Addendum No. 2

DATE: January 15, 2025

FOR: **Constructing Bridge #01701191 on Farm Road 17 over Sac River, Greene County, Missouri**
BRO-B039(038)

STA. 7+25.00

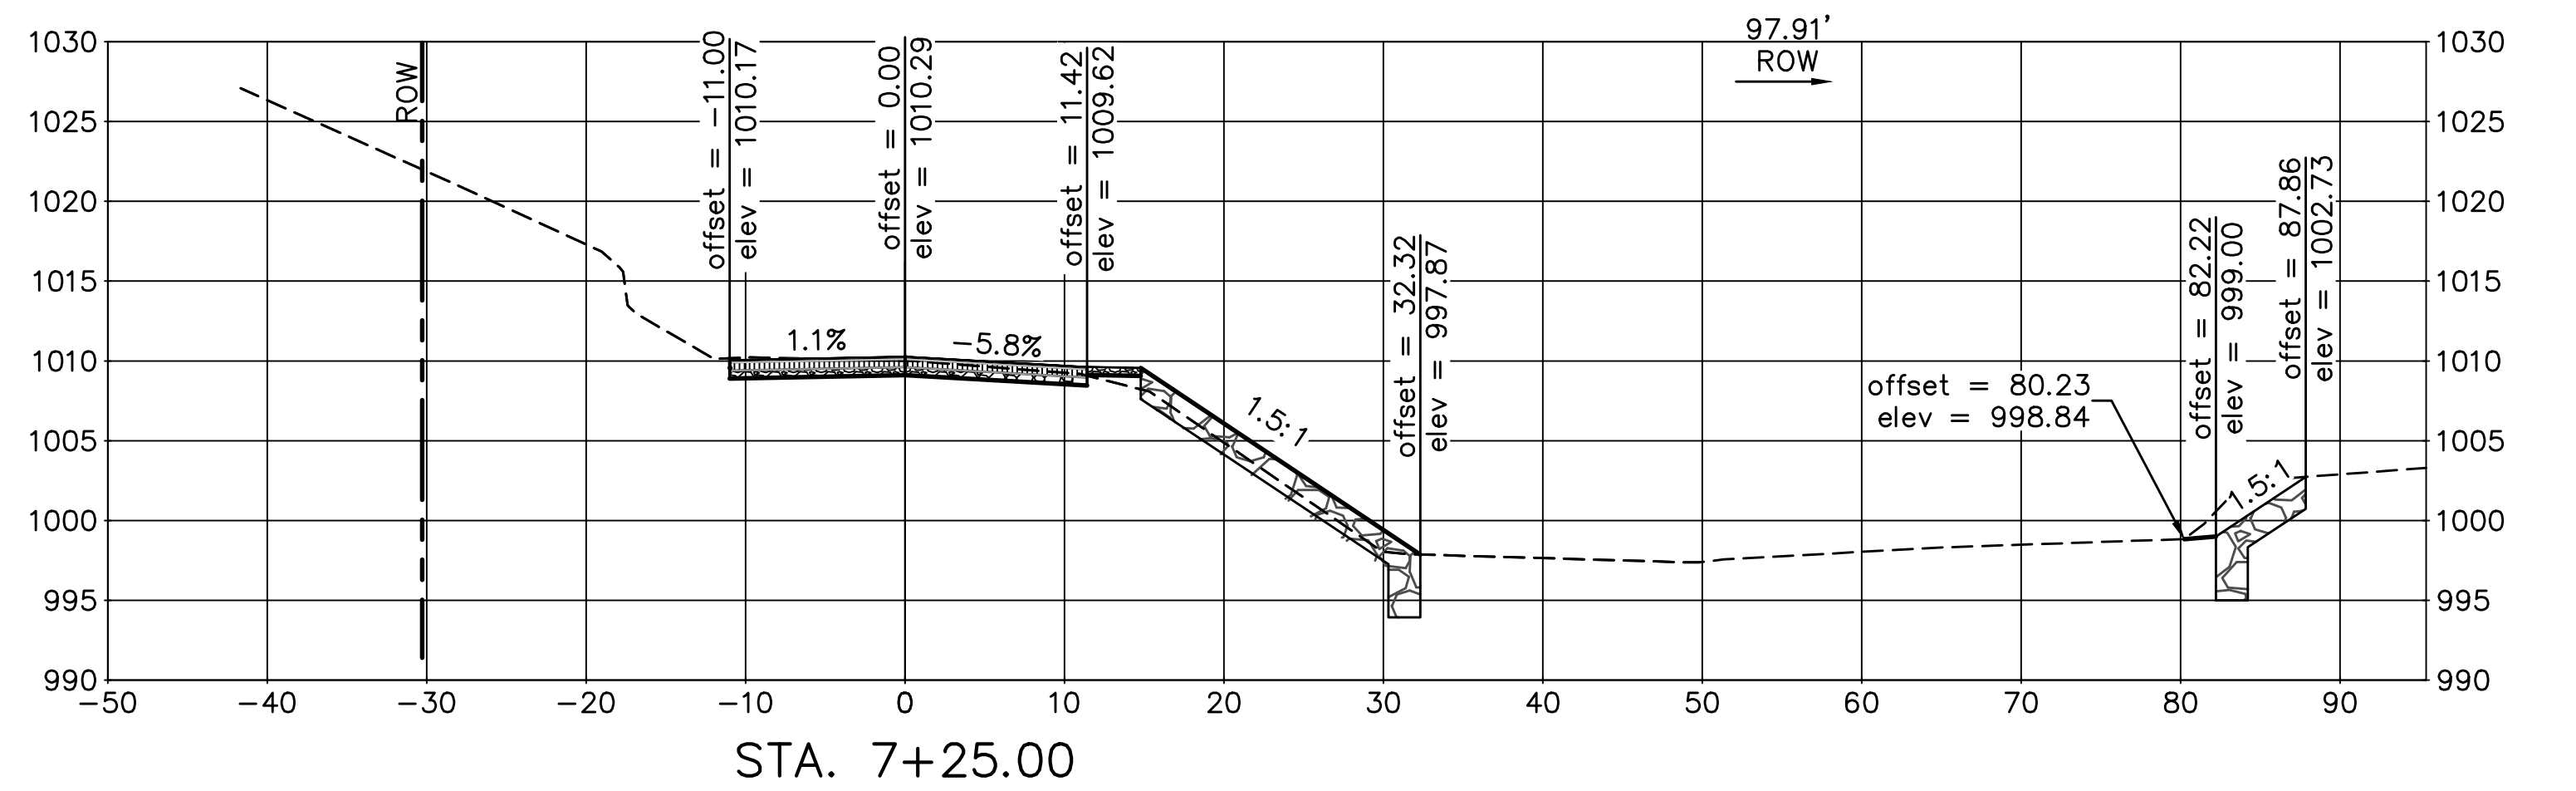
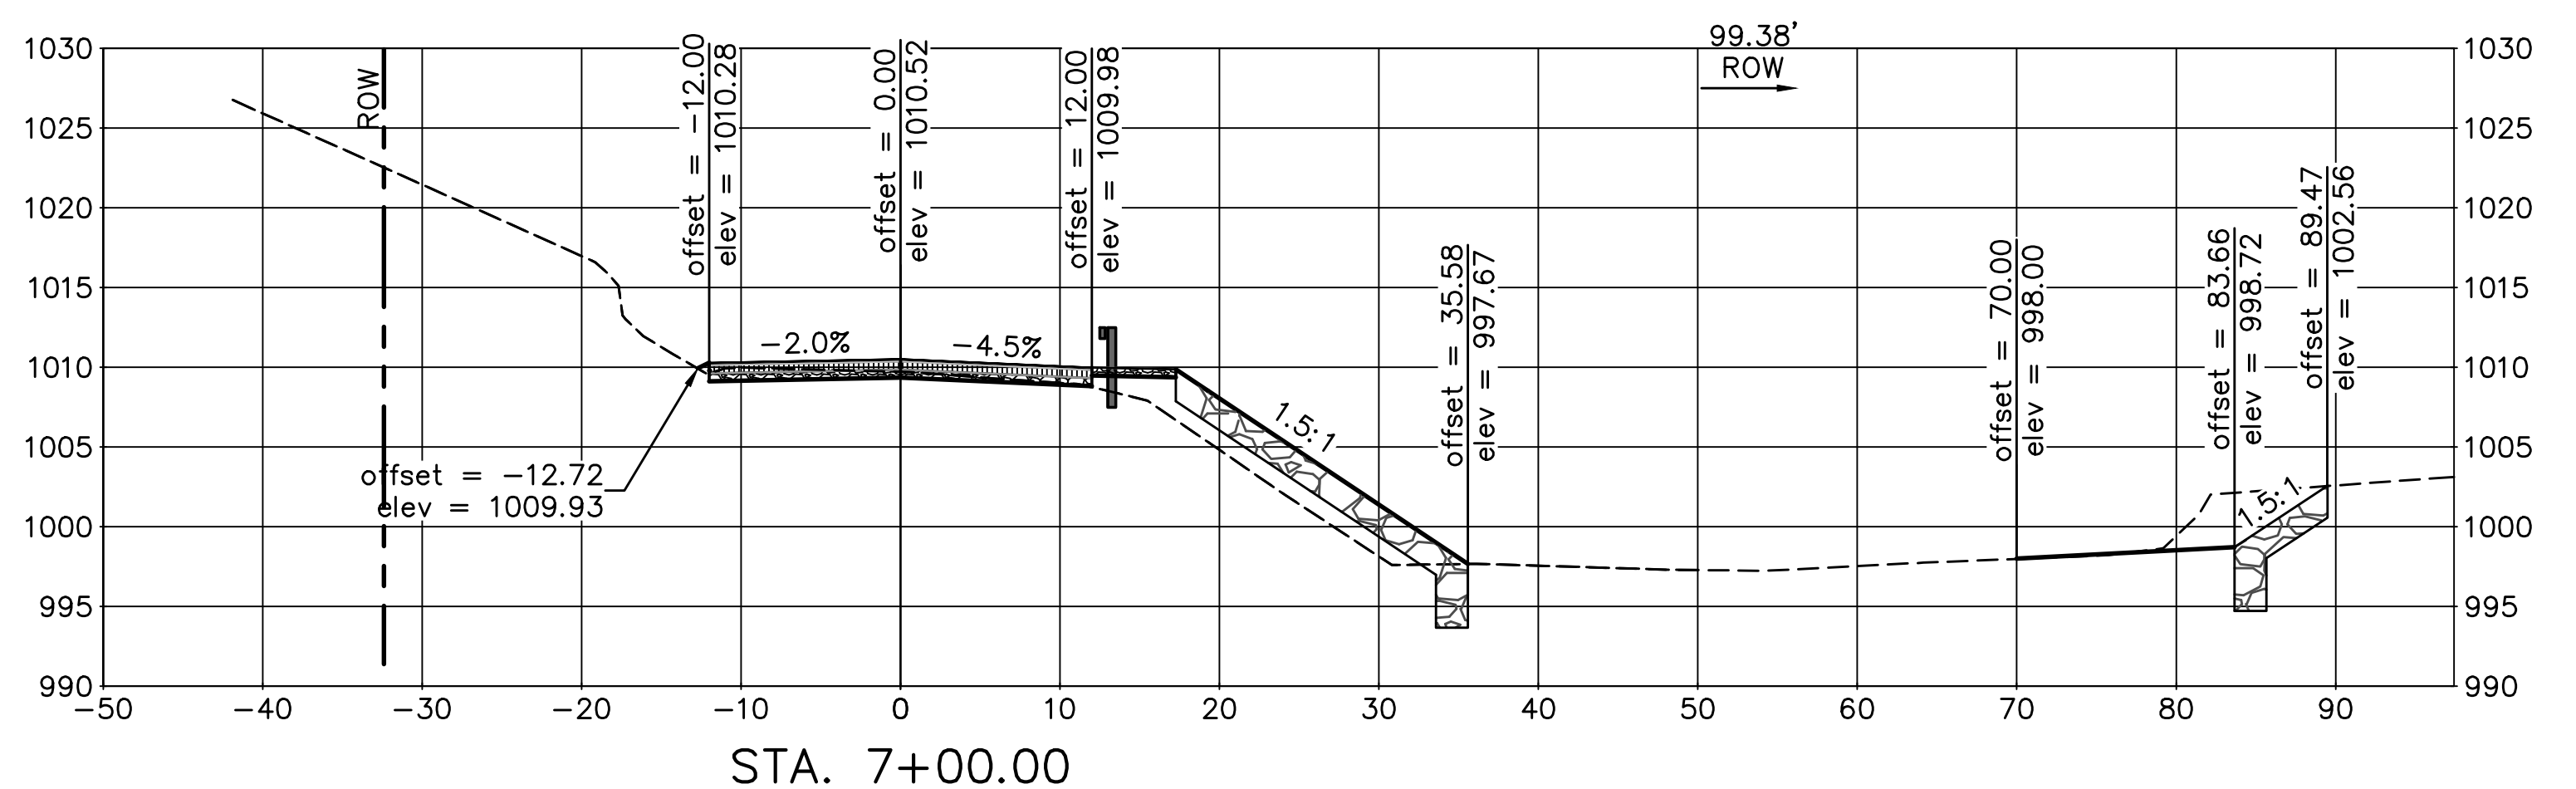
Question 4: Our grading quantities based on the proposed and existing contours in the plans are considerably higher than the plan quantities. Could the CAD files be made available so that we could verify the grading quantities?

Answer 4: Cut and fill quantities have been revised. A new bid form and updated plan sheets showing the estimated quantities are included with this addendum. CAD files can be provided upon request to Greene County Highway Department.

EARTHWORK QUANTITIES
 CUT = 1087 CY
 FILL = 1927 CY
 NO ADJUSTMENT HAS BEEN MADE FOR SHRINKAGE OR SWELL
